Arboricultural Assessment & Report – Development Impact

104 – 108 Sparks Road Norlane

For: Misk Design

Tuesday 2nd June 2026

PROPOSED SITE AND FLOOR PLAN - FRONT

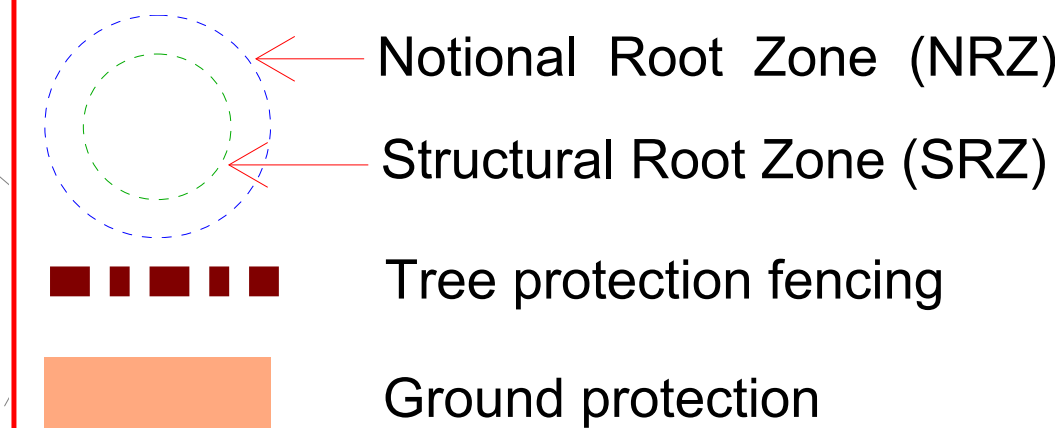
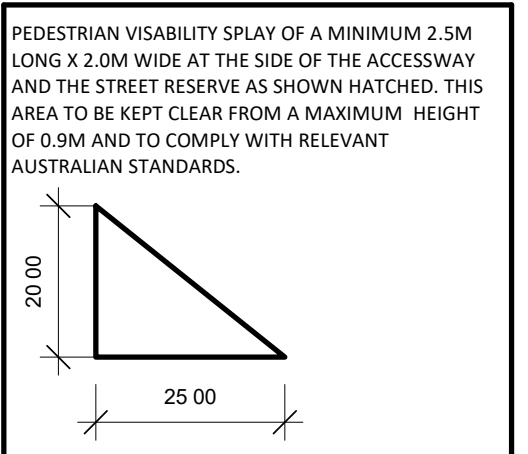
A preliminary design assessment, undertaken on the 19th May 2026, indicated major encroachment to the NRZ of street tree 1 at 13.5%, with the SRZ also encroached. Following arborist advice, the design has been amended to reduce the level of encroachment to the NRZ and to remove any encroachment within the SRZ.

I have assessed *Proposed Site and Floor Plan - Front*, drawn by Misk Design, undated, received on 01.06.2026.

- The NRZ area of trees 1 & 2 is encroached by a minor amount.
- Zero NRZ's are encroached a moderate amount.
- Zero NRZ's are encroached a major amount.

Regarding a minor encroachment, AS4970 2025 states that generally, it is unlikely that there will be a significant impact to tree health, longevity or structure. Therefore, the health of trees 1 & 2 will not be materially affected by the minor encroachment of 9.9% and 0.2% respectively.

Tree protection measures must be installed prior to the commencement of works. Indicative tree protection measures are provided on plan in Appendix 4.

The crossover excavation within the NRZ of tree 1 must be attended by a suitably qualified arborist. All severed roots must be pruned, treated and backfilled immediately. No root loss is to occur that would undermine tree health.

Where underground services must be installed within a NRZ, these must be underground bored to a nominal depth of 600mm and under direct arborist supervision.
